# Smart Motorways Programme

## M4 Junctions 3 to 12 Smart Motorway

Non-Material Change  
Oldway Lane Overbridge  
Technical Note

Document Number: HA514451-CHHJ-GEN-SZ\_ZZZZZZZZ\_Z-TN-KK-0080

Figure 2 2021 NMC Design of Oldway Lane overbridge

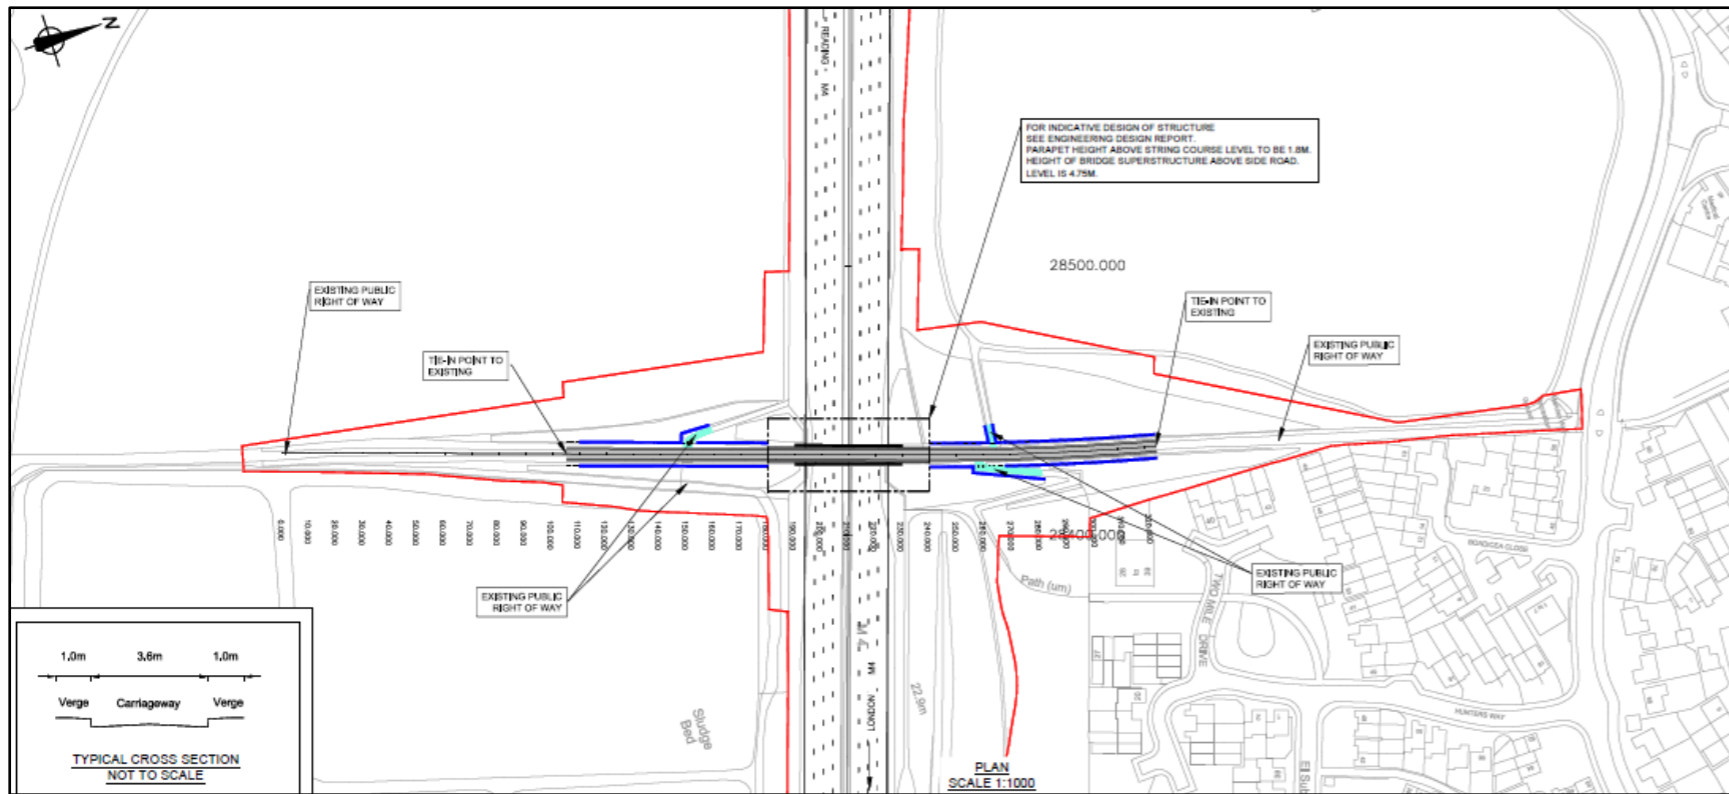
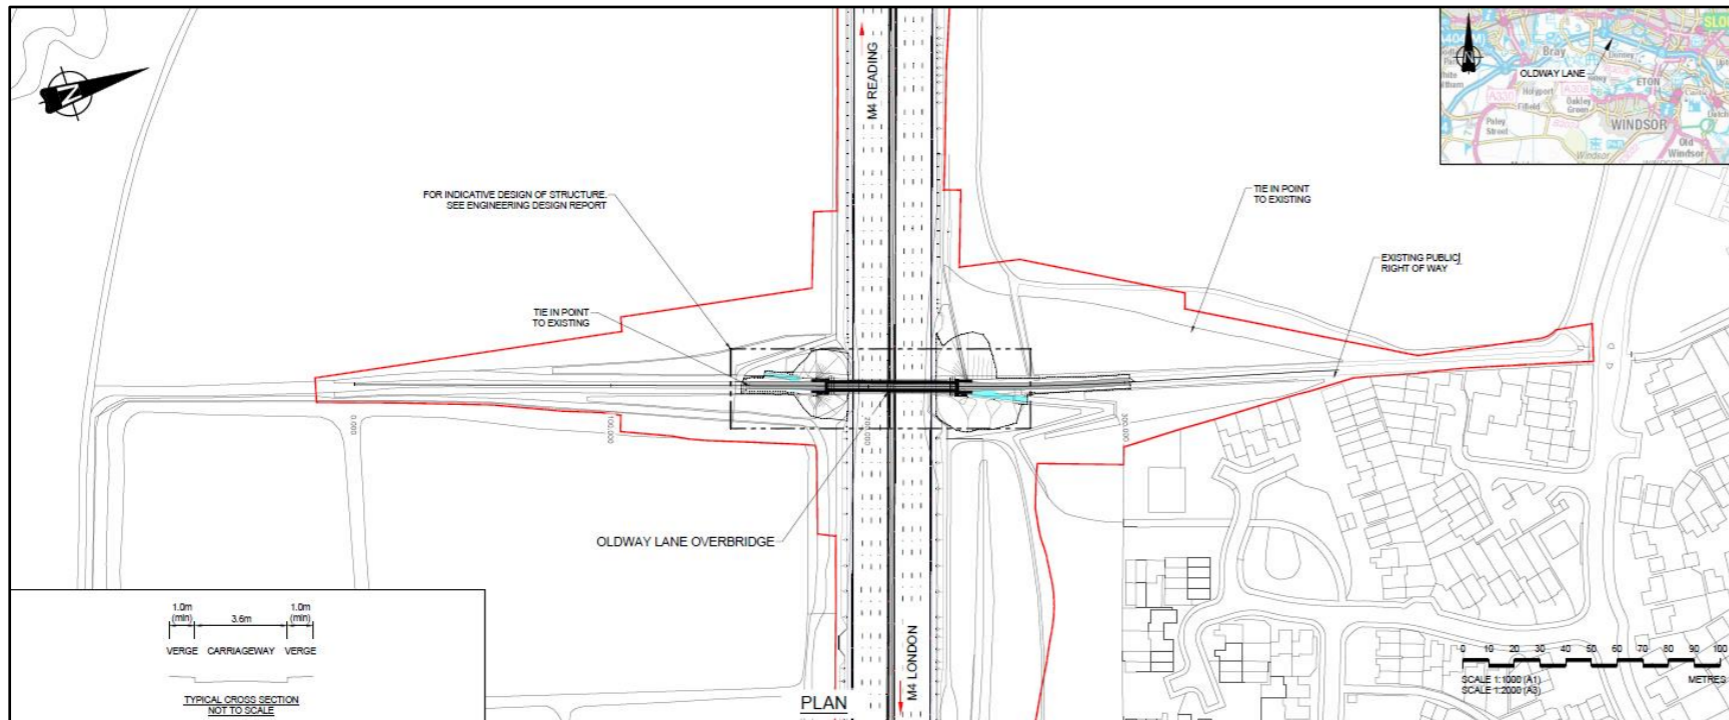
The proposed replacement structure is a single-span truss bridgeway overbridge. The drawings for the bridge included in the 2015 Engineering and Design Report stated that the top surface of the top chord (the curved uppermost member of the truss bridge) would be 4.75m above the bridgeway surface at the bridge midspan, implying that the overall structural depth of the truss at midspan would be approximately 5.1m.

During detailed design, the maximum overall depth of the truss was reduced to 4.05m in order to facilitate road transportation of the truss in two segments with a series of simple bolted connections at the midspan. A truss depth in excess of 4.1m would have required the main structural members to be transported separately from the deck plates and transverse members. This would have requiring extensive on-site assembly of the bridge components increasing construction cost and duration of the works and introducing exposing the workforce to additional risks due to the on-site welding work required. Under the proposed design, the distance at midspan from the bridgeway surface to the top of the top chord is reduced to 3.737m.

In addition, the overall vertical profile for the side road has been lowered by up to 0.5m, such that the proposed bridgeway is now approximately 0.8m higher than the existing structure. This change has facilitated the removal of significant lengths of retaining walls on both approaches to the overbridge.

The combined effect of the lowered side road profile and the reduction in truss depth means that the top of the bridge top chord is a total of 1.51m lower than the levels shown in the engineering sections and drawings

New earthworks, that will largely be constructed within the footprint of the existing earthworks, will be required to locally raise the side road alignment to tie into the new reduced height bridge (refer to section 4.4 for further details). Furthermore, the southern tie in of the proposed works has been curtailed on the south side of the M4 to ensure it fits within Local Authority land.

The proposed footpath links in the northeast and southwest corners have been subject to minor re-alignments to reflect the updated design. These changes are shown in Figure 2 and will have no impact on the routes or connectivity to the bridgeway/footpath network in the area.

Figure 6 Extract of detailed landscape design shown on the ENGINEERING AND DESIGN REPORT, ENVIRONMENTAL MASTERPLAN (P01, S2, HA514451-CHHJ-ELS-SZ\_ZZZZZZZZ\_Z-DR-LD-5200 to 526518/02/22)

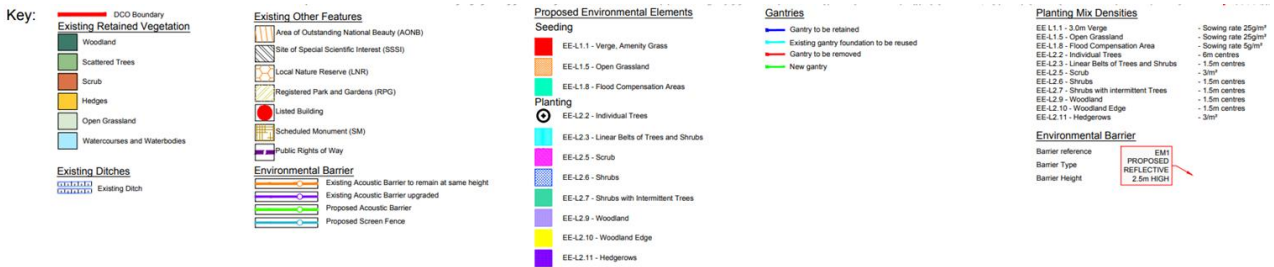
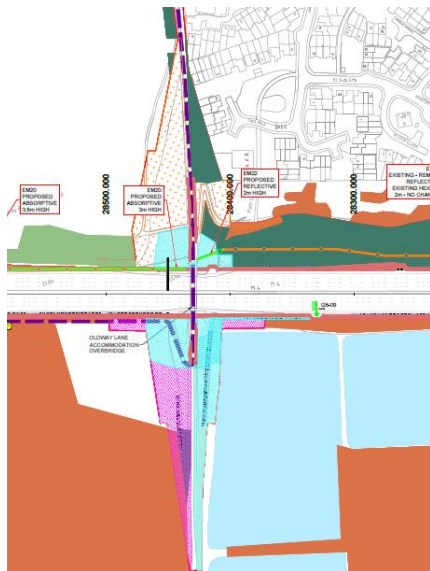
A change assessment of the residual landscape and visual effects of the 2021 NMC Design against the baseline information presented in the ES is presented in Tables 3, 4 and 5 with a summary of the changes provided below.

No additional vegetation clearance in this area.

No change of landscape proposals.

No change.

Earthworks/Retaining Structures: no impact on planting design.

No change of the visual amenity for all sensitive receptors listed above.
